Transport
for NSW

Wynyard Station Upgrade

Review of Environmental Factors – Submissions Report

March 2015

Figure 1 - Proposed Wynyard Station - revised concourse layout (indicative)

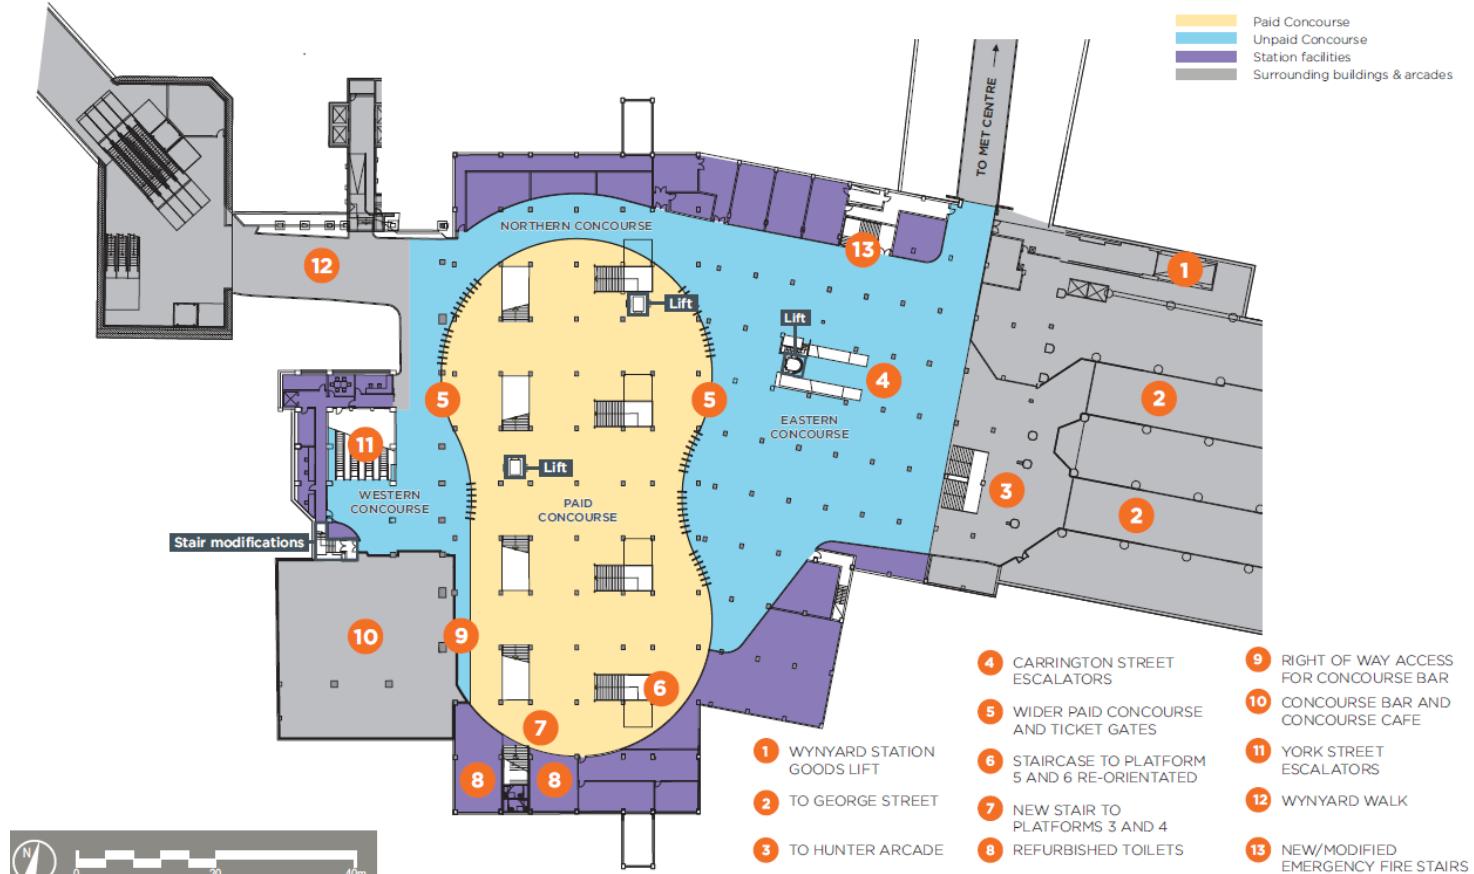
Item	Issue	Summary of issue	Stakeholder Response number
		<p>proposed under the proposed design.</p>	<p>be subject to separate approval under Part 4 of the EP&A Act.</p> <p>Areas nominated as ‘station facilities’, as shown on Figure 1, would not be solely used for potential retail. These areas would also be used for station back-of-house uses, such as storage areas, Station Manager’s Office, toilets and change rooms, services and plant rooms, general office space and meeting rooms.</p> <p>The final partitioning and fit out of the station facilities would be subject to detailed design and future commercial negotiations. The division of space between back-of-house, office and storage, services and utilities, and retail would be determined based on station operational, access and safety requirements.</p> <p>The use and final fit out of future retail or commercial spaces would be subject to separate assessment, however the proposal includes servicing of these spaces to support their future use.</p>

- The Station Manager's Office would be located on the concourse level with direct access to the eastern unpaid concourse and paid concourse within areas designated for station facilities (refer to Figure 1). The basement levels of Transport House would continue to be developed for back of house uses.
- The Concourse Bar and Café would no longer be acquired and would be incorporated into the final concourse design. This would require adjustments to the western unpaid concourse and western ticket gateline.
